City of Santa Fe, New Mexico

Attachment A Conditions of Approval and Technical Corrections

Case #2025-11753 & 2025-11756. 1750 and 1802 Cerrillos Rd, 3 RD Berry Ave, and 1361 Fourth St Development Plan and Special Use Permit. B Constructiv LLC and Sommer Karnes & Associates LLP, "Agents" for Amatren, LLC, Owner and Applicant ("Applicant"), request approval of a Development Plan and Special Use Permit to redevelop the properties listed above into a self-storage facility with community office and gathering spaces. The property is zoned C-2 (General Commercial) and is within the Suburban Archaeological Review District. (Alexa Hempel, Case Manager, anhempel@santafenm.gov).

This application has been reviewed by Planning Division staff (Staff) and the City's Development Review Team (DRT). Attached are the initial DRT review comments including conditions of approval and technical corrections. Additional corrections may follow throughout the development review and permitting processes. I would like to highlight and summarize the following key items. **Those items in green font must be completed prior to planning commission.** Items in black will need to be completed at later dates (refe

Illustration 14-9.2-1: **Street** Types Design

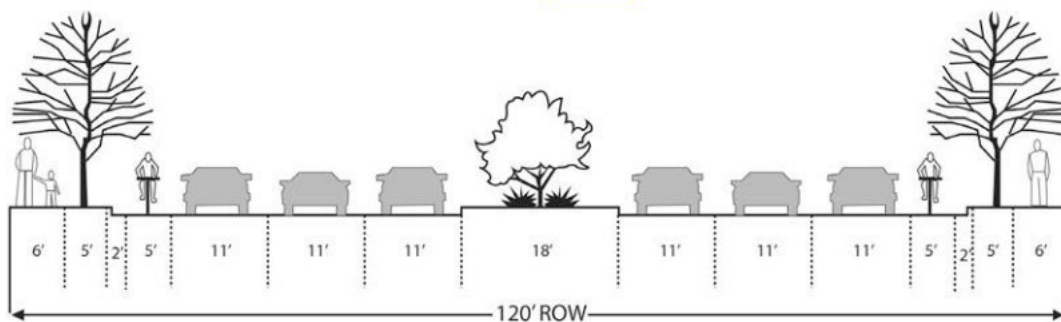
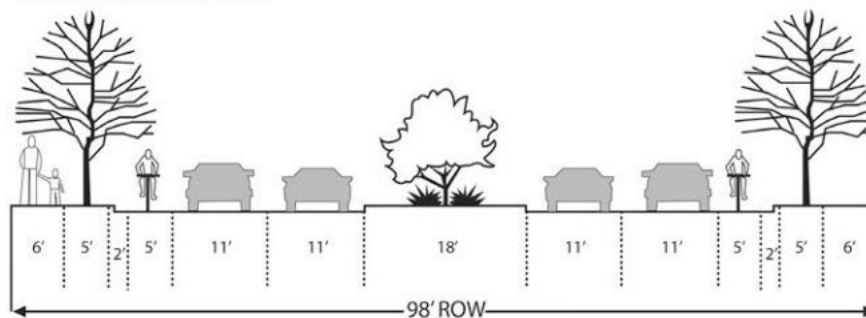
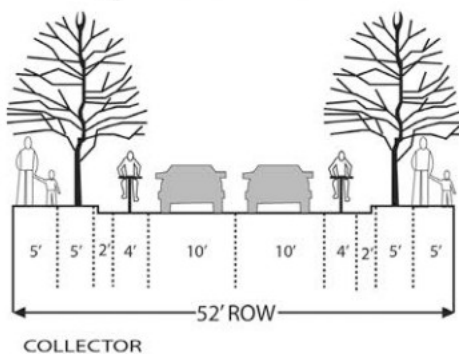
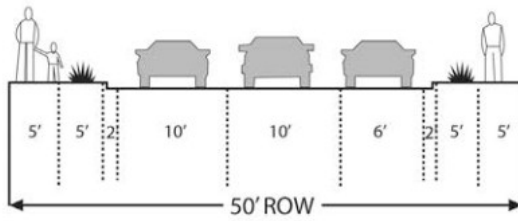
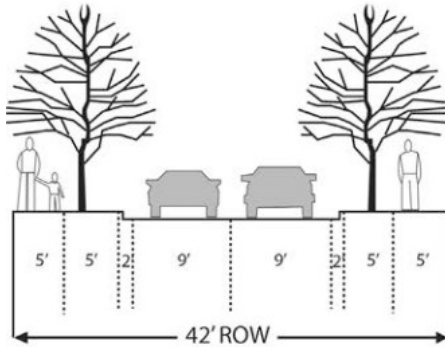
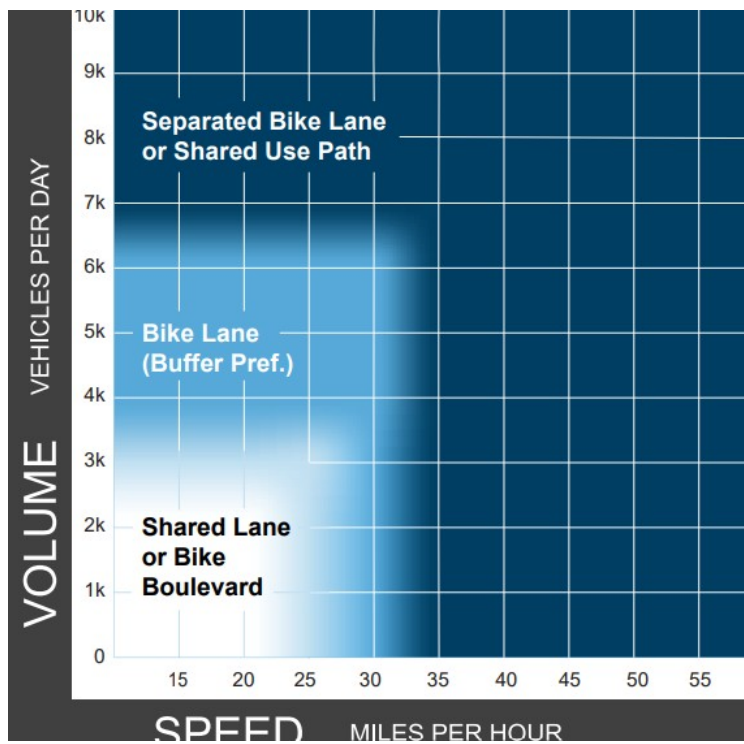
- 5. **MPO**
 - a. Sidewalk should align with Cerrillos Road Plan specs and city street design standards which require 5' landscape buffer between street and pedestrian path (See comments on plans for detail). Sidewalk width should be at least 6', but also made as wide as possible on Cerrillos. FHWA and AASHTO guidance support a separated bike facility given the vehicle speeds and volumes here. By expanding the sidewalk to the minimum for a shared use path (10') this would better align with federal guidance.

See City Street Standards below for sidewalk and landscaping buffer requirements

EMPIRE SELF STORAGE SITE PLAN

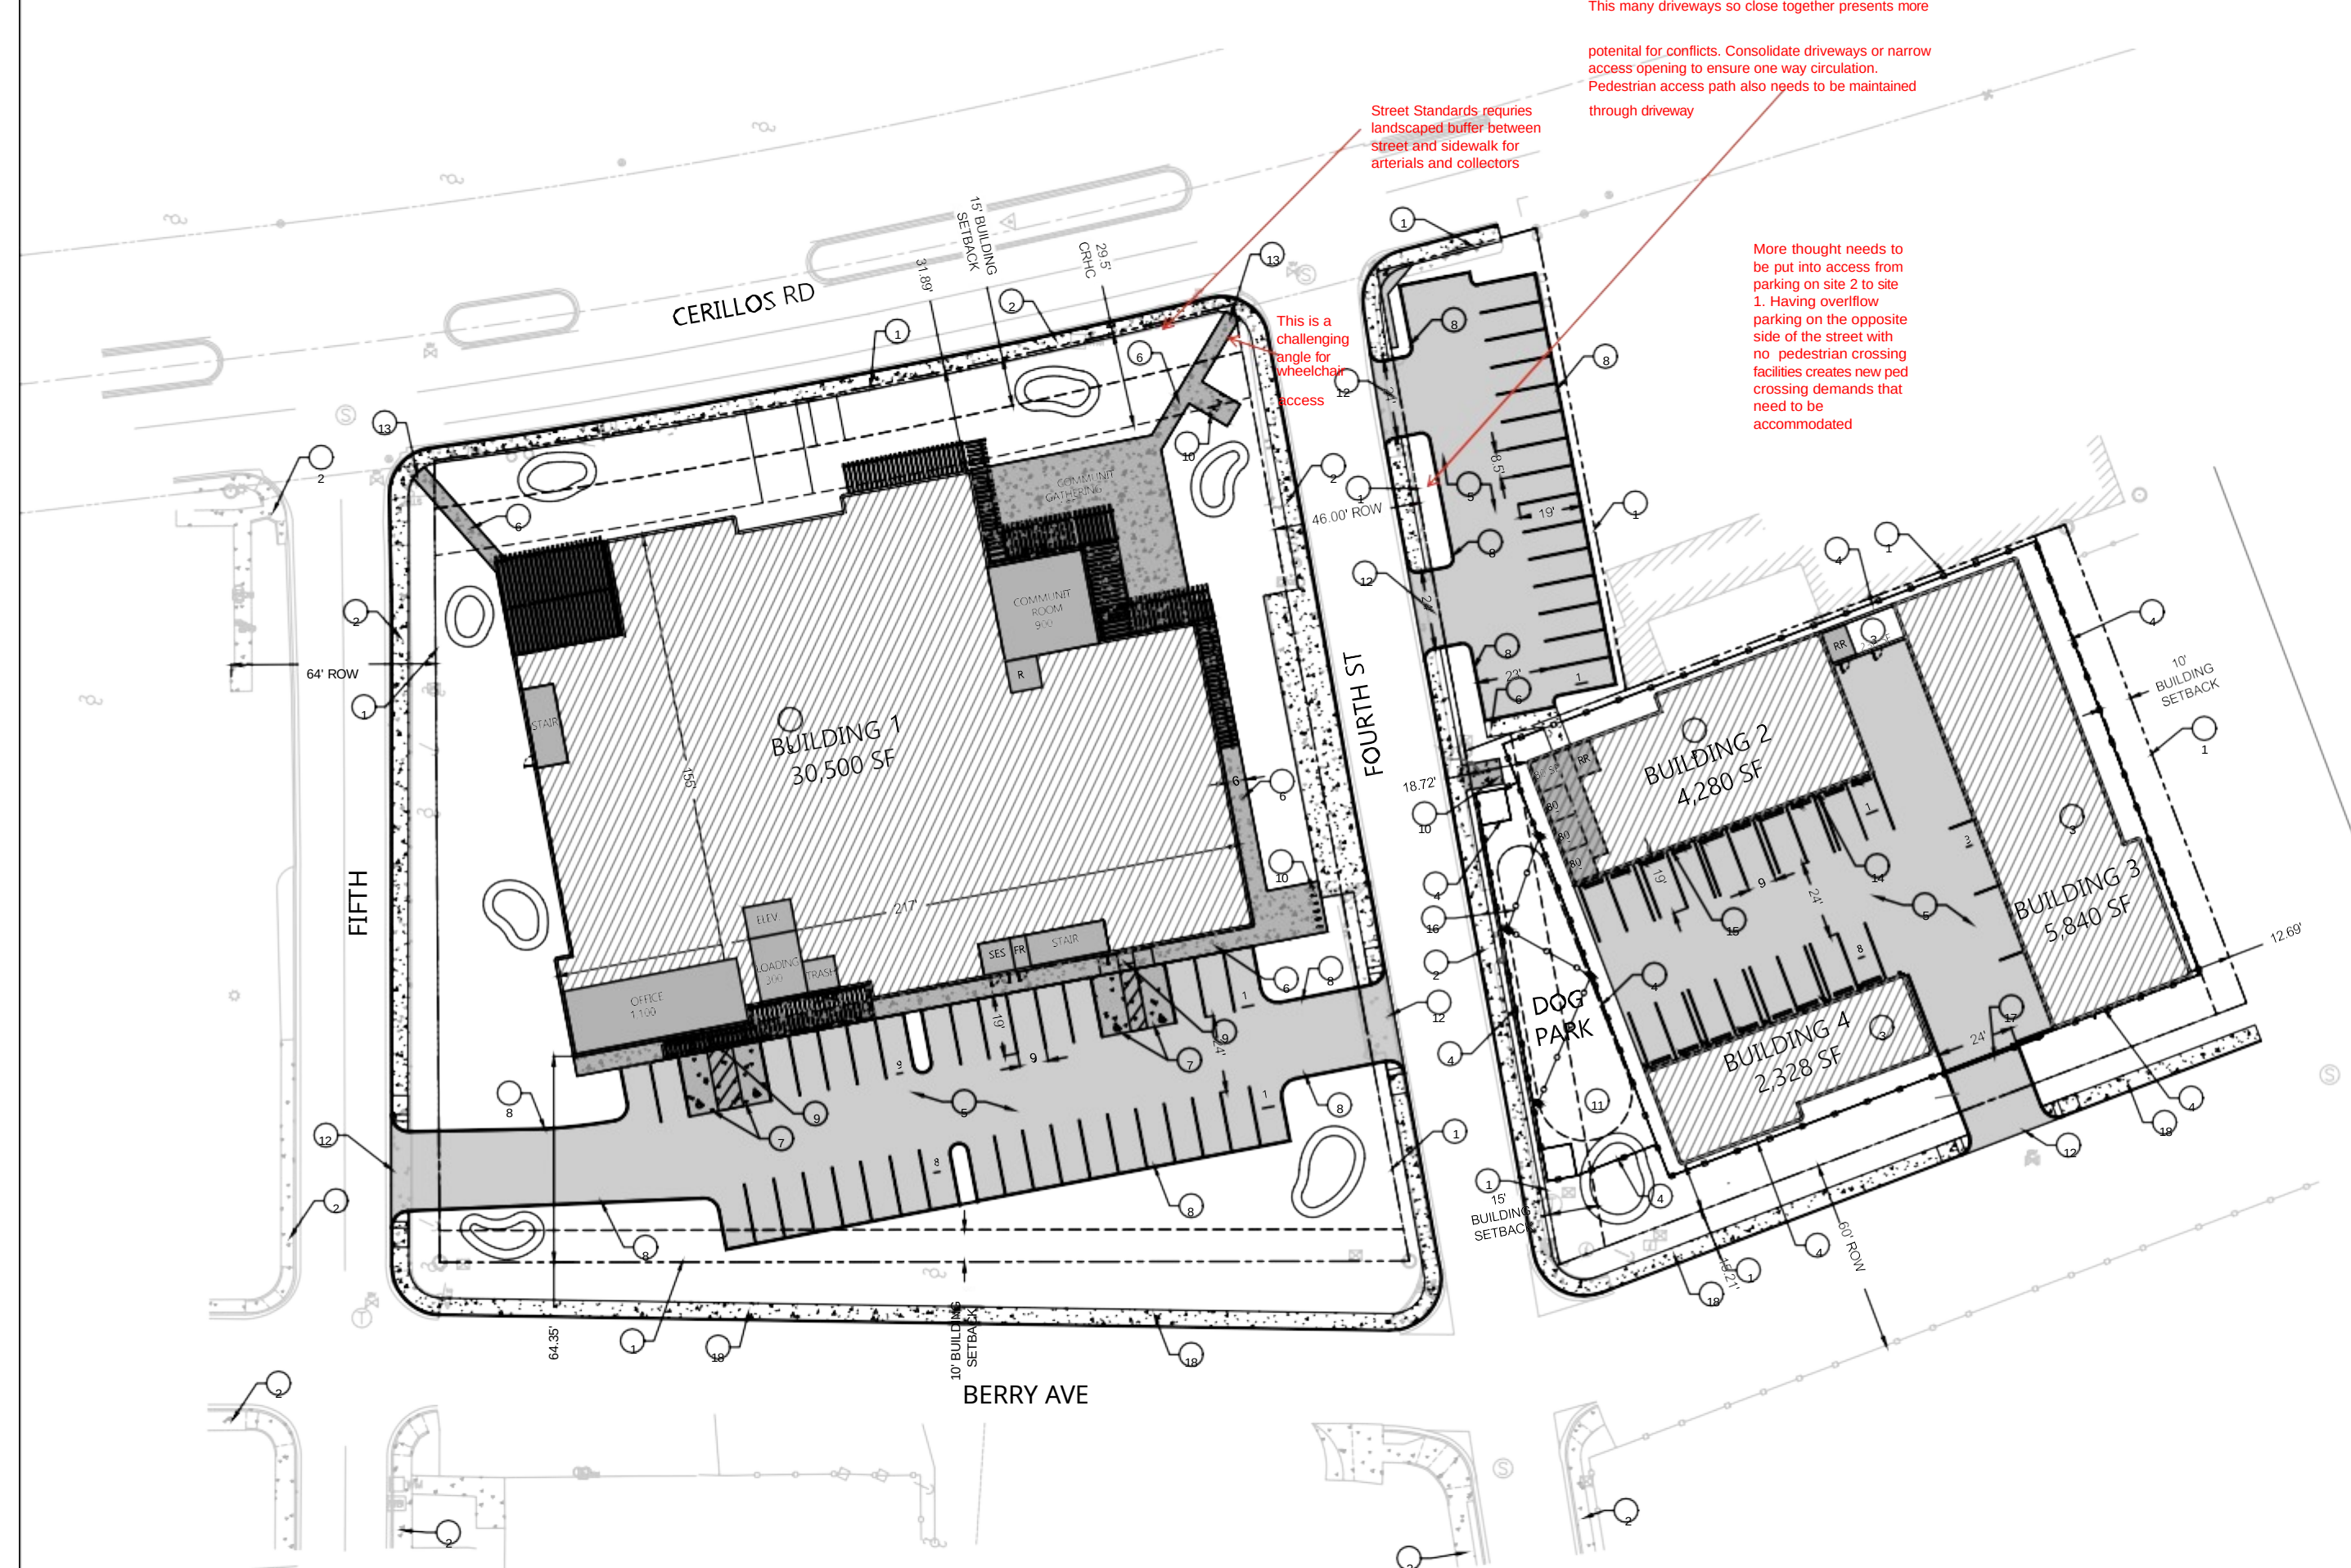
- e. Fencing oddly crosses retention pond (C-201)
- f. The dog park should be designed and constructed to capture the first flush of surface runoff in order to reduce water quality impacts. As currently depicted, the grading plan does not direct runoff in a manner that would enable the pond to function as intended (sheet -304)

4. Fencing oddly crosses retention pond (C-201)	note	
5. The dog park should be designed and constructed to capture the first flush of surface runoff in order to reduce water quality impacts. As currently depicted, the grading plan does not	Prior to development plan approval Prior to recordation	
direct runoff in a manner that would enable the pond to function as intended (sheet -304)

E.101 $1'' = 30'-0''$

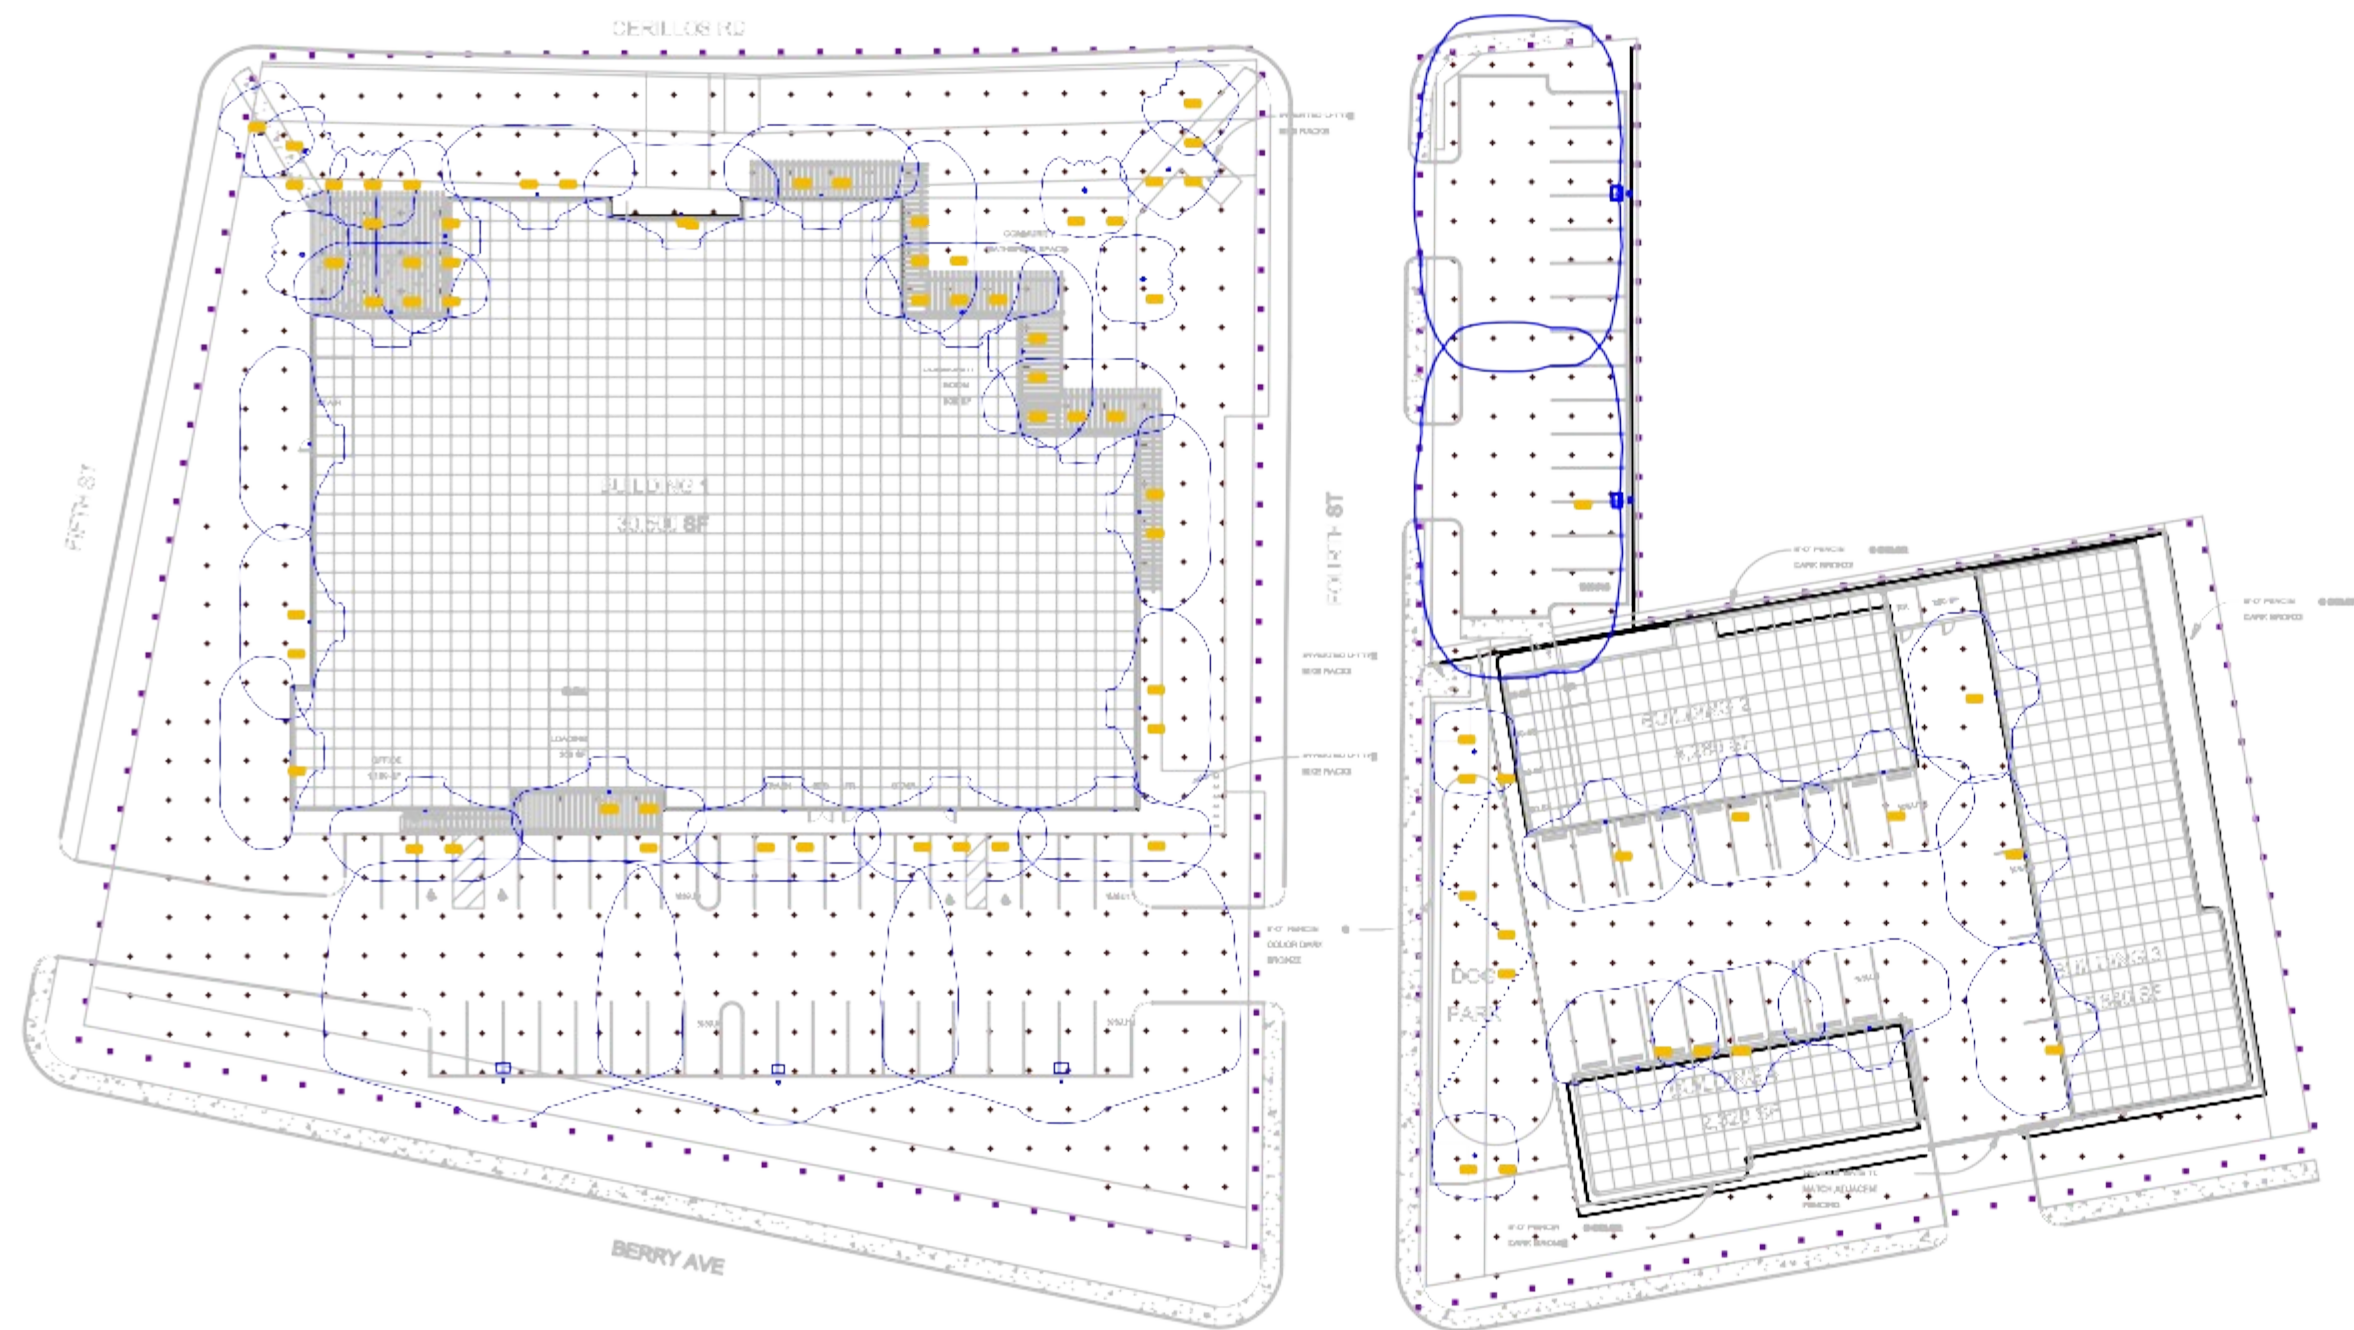
- h. Utilize organic mulch within the landscape particularly at mass plantings. Provide wood mulch shredded or chipped 4-inches in depth without weed fabric.
- i. Provide fencing information and detail.
- j. Irrigation system design is incomplete. Provide the remaining zone layouts.
- k. Provide the correct details from the LIDS manual for the Manual Drain, Backflow Preventer.
- l. Provide a water budget for the first three months of the Turf establishment period.
- m. Turf grass sod or turf grass seed mixes installed within the city limits shall contain no more than twenty-five percent Kentucky Bluegrass.
- n. Photometrics do not meet Code requirements. See Article 14-8.6(D)(2) and revise for compliance. 74-points exceed the maximum illumination for any point. (Highlighted numbers attached are out of compliance)
